INDEPENDENT EXPERT ADVISORY PANEL FOR MINING

***Metropolitan Coal Mine:
Independent review of environmental
performance to 2022
(Dupen, 2023)***

Report No: IEAPM 202309-2

Figure 16: Groundwater hydrographs for transect boreholes T1 to T6. (Figures 3 and 4 from SLR, 2023a)

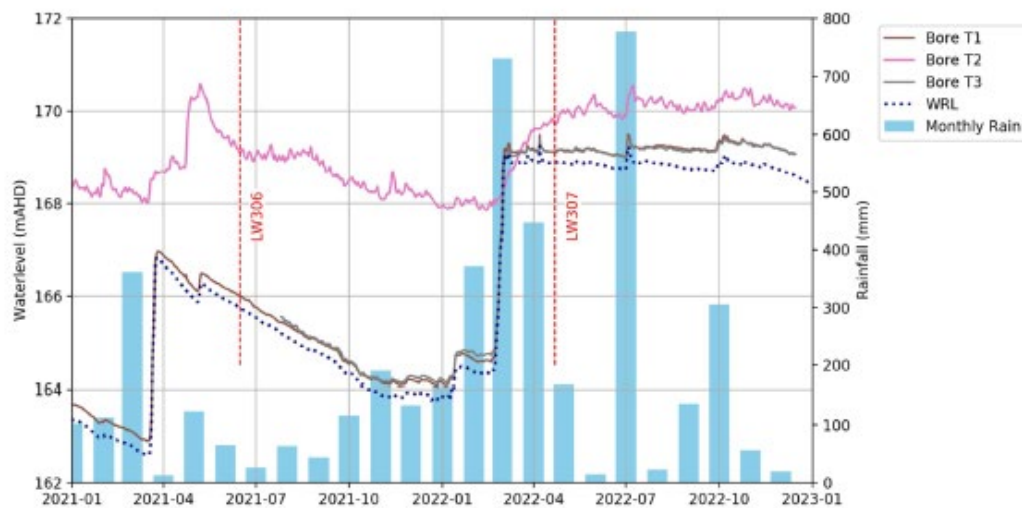
Two of the five transect boreholes (T3R and T1) confirm the intersection of a fracture zone that is hydraulically connected to the Woronora Reservoir. Water levels at these two sites rise and fall with reservoir levels. The latest published trends for all six transect bores are shown in Figure 16.

For the Hawkesbury Sandstone aquifer, there are many monitoring sites at ridgeline locations with multiple depth sensors that show no evidence of aquifer depressurisation or drainage (SLR, 2023b). Many sites show subtle increases in water table levels during recent years as a result of increased rainfall recharge and/or an increase in the Woronora reservoir level. However, the borehole T1 to T5 transect does show some evidence of mining-induced water level declines (Figure 14 in this report taken from SLR, 2023a):

- Water level in Borehole T5 has declined by 10-12 m since the commencement of LW305;
- Water level in Borehole T4 (inoperable since August 2021) declined by approx. 5 m at the commencement of LW306; and
- Water level in the original Borehole T3 declined by approx. 5 m at the commencement of LW305 but has since risen in the deeper replacement bore T3-R with the increase in the reservoir storage levels.
